LR-N04-0183  
LCR H04-03

**REQUEST FOR CHANGE TO TECHNICAL SPECIFICATIONS  
SAFETY LIMIT MINIMUM CRITICAL POWER RATIO  
HOPE CREEK GENERATING STATION  
FACILITY OPERATING LICENSE NPF-57  
DOCKET NO. 50-354**

**REQUEST FOR CHANGE TO TECHNICAL SPECIFICATIONS  
SAFETY LIMIT MINIMUM CRITICAL POWER RATIO**

**HOPE CREEK GENERATING STATION  
FACILITY OPERATING LICENSE NPF-57  
DOCKET NO. 50-354  
REVISIONS TO THE TECHNICAL SPECIFICATIONS**

Figure 1  
Reference Loading Pattern – Hope Creek Cycle 13

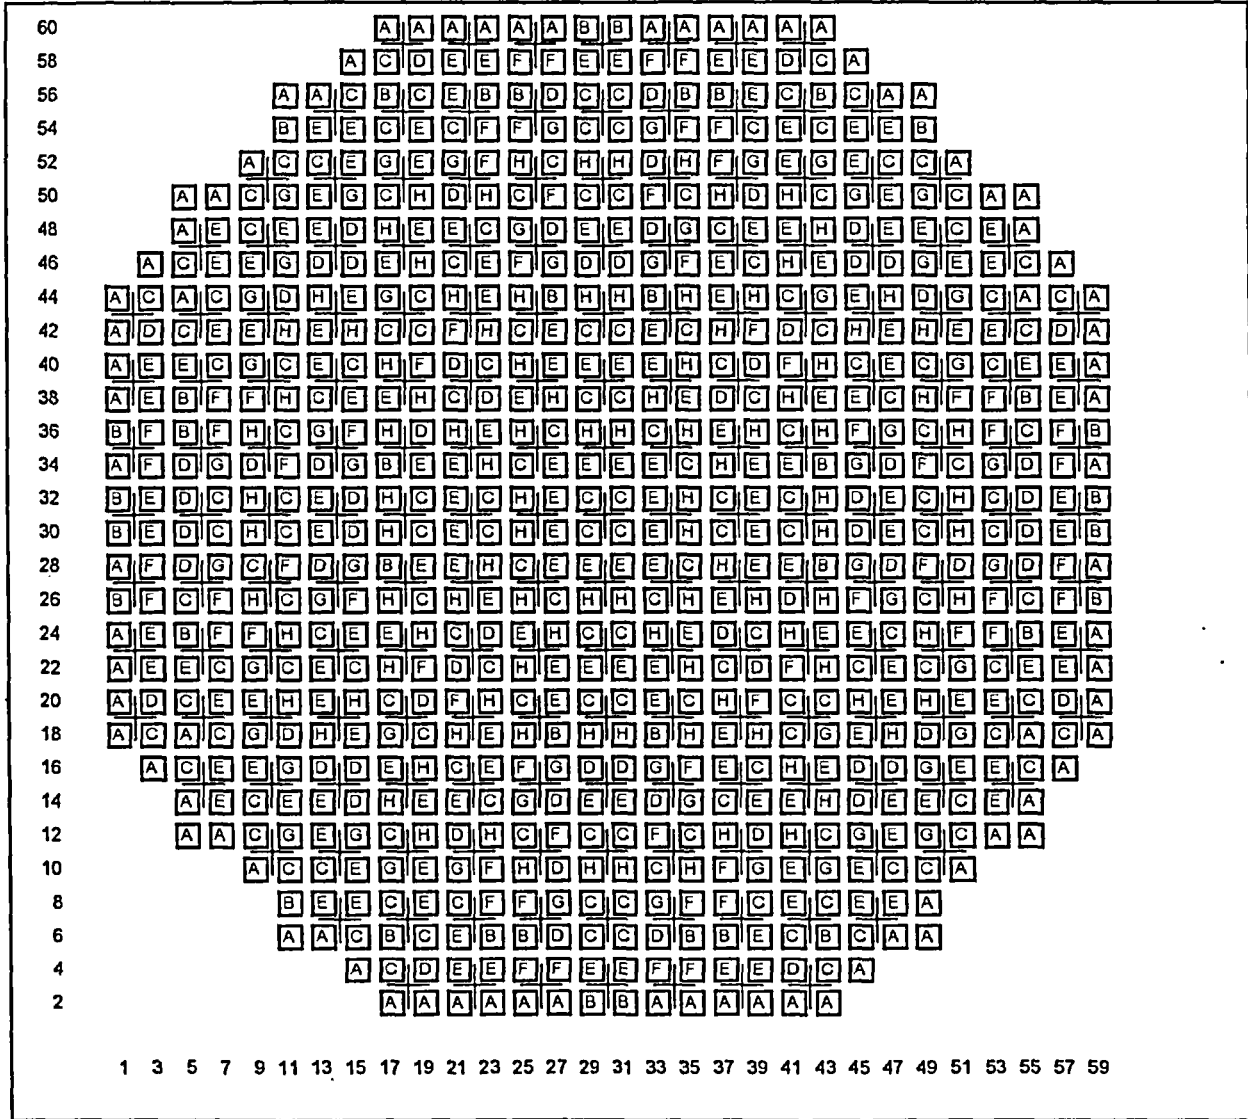
The core loading information for Hope Creek Cycle 13 is provided in Figure 1. The impact of the fuel loading pattern differences on the calculated SLMCPR is correlated to the values of [[
